Development Facilitation Team (DHO) – Review Comments

Project No: PR-2018-001579 **Date:** 7/30/2025 **Agenda Item:** #1 **Zone Atlas Page:** J-18, J-19

Request: Major Preliminary Plat review

Application For: MAJOR PLT-2025-00009 – MAJOR PRELIMINARY PLAT

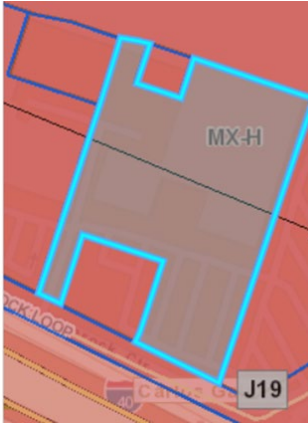
- Subdivide Tract D 2.0002 deeded acres into two new tracts D-1 at 1.5857 acres and D-2 at .4145 acres.

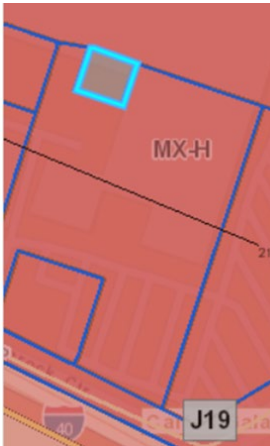
- Tract F-3 of .2145 deeded acres, a lot line adjustment, into F-3A at .2603 acres.

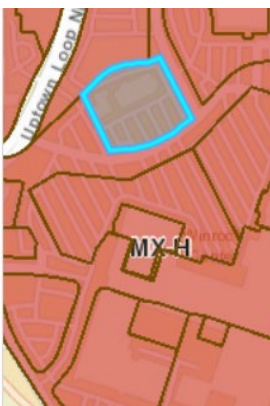
- Tract H of 2.4388 deeded acres, a lot line adjustment, into H-1 at 2.5631 acres.

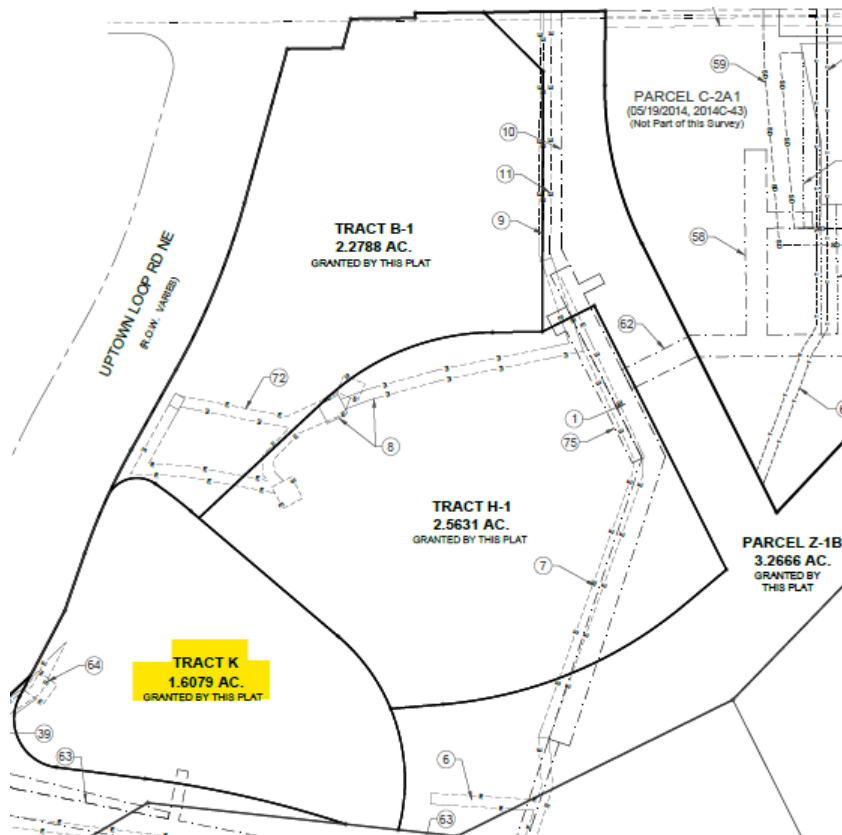
- The incorporation of Tract B of 2.4765 deeded acres, of the Hunt Spectrum subdivision into the Winrock Center Addition, and the creation of Tract B-1 into 2.2788 acres.

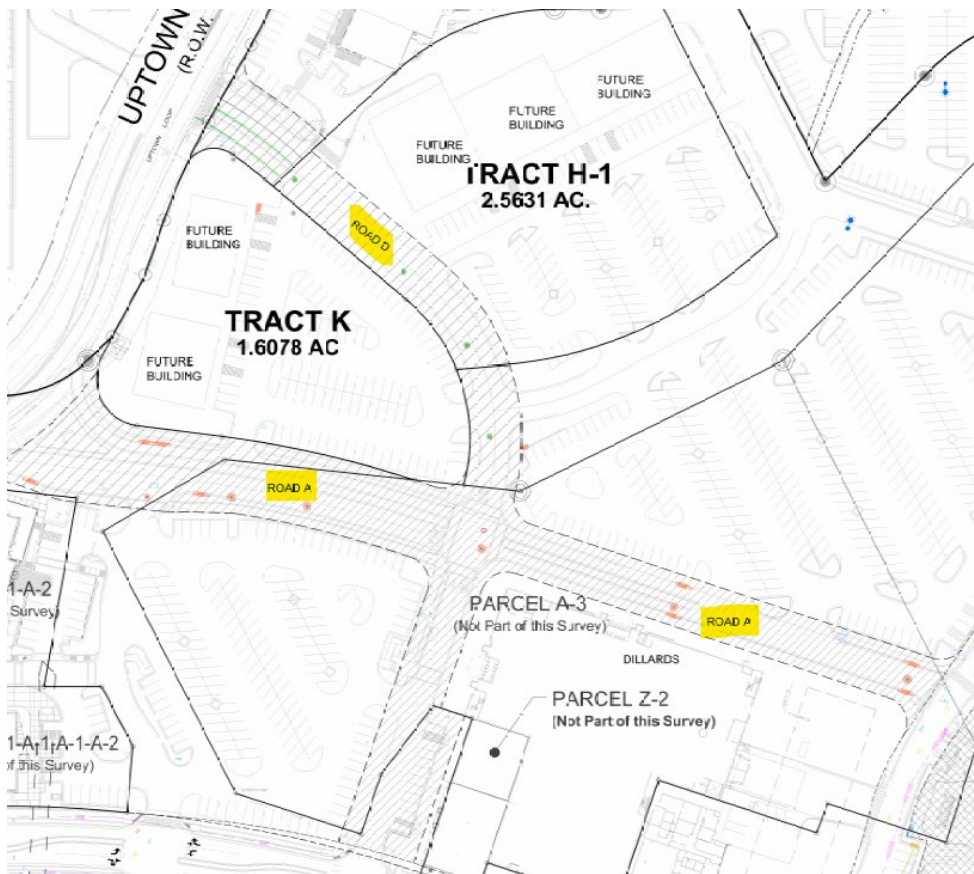
- The creation of Tract K at 1.0678 acres from portions of tracts Z-1, B and H.
